TOWN CENTER FOUNTAIN SHOPS JSP14-24

Consideration of the request of Novi Town Center Investors for recommendation of approval to the City Council of Preliminary Site Plan and Stormwater Management Plan. The subject property is 47.77 acres in Section 14 of the City of Novi and located at the intersection of Ingersol Dr and Crescent Blvd in the TC, Town Center district. The applicant is proposing a 7,108 square foot retail building.

PLAN REVIEW CENTER REPORT

Novi Town Center Fountain Shops JSP 14-24
 Preliminary Site Plan Review
 Plan Date: 06-02-14

EAST ELEVATION

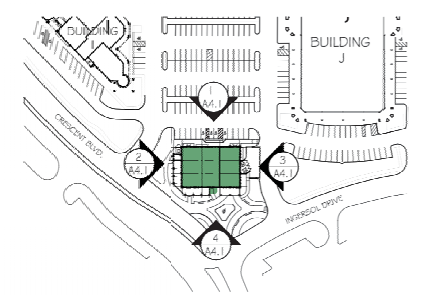
The following is the Façade Review for Preliminary and Final Site Plan for the above referenced project based on the drawings prepared by Yah Yee Associates, Architects, dated June 2, 2014. The percentages of materials proposed for each façade are as shown on the table below. The maximum (and minimum) percentages allowed by the Schedule Regulating Façade Materials of Ordinance Section 2520 are shown in the bottom row. Materials that are in non-compliance with the Façade Schedule are highlighted in bold.

West	East	South	North	Ordinance Maximum (Minimum)
BRICK	64%	58%	62%	65%	100% (30%)
EIFS	22%	21%	24%	20%	25%
MOLDED CORNICE & TRIM (EIFS)	6%	5%	5%	9%	15%
CAST STONE	6%	8%	9%	6%	50%
STANDING SEAM METAL	2%	8%	0%	0%	25%

Recommendation: As shown above all proposed materials are in full compliance with the Façade Chart of Section 2520, and Sections 1602.9 which requires that facades materials in the TC district be primarily of Brick and Stone. The use of non-copper colored standing seam metal (note 3 of the Façade Chart) is consistent with the Section 9 Waiver previously granted by the Planning Commission on this project. This application therefore qualifies for administrative approval as described in section 2520.9 of the Façade Ordinance, provided that the eligibility requirements of Section 2516.c are met.

The building facades were found to be in full compliance – response not required.
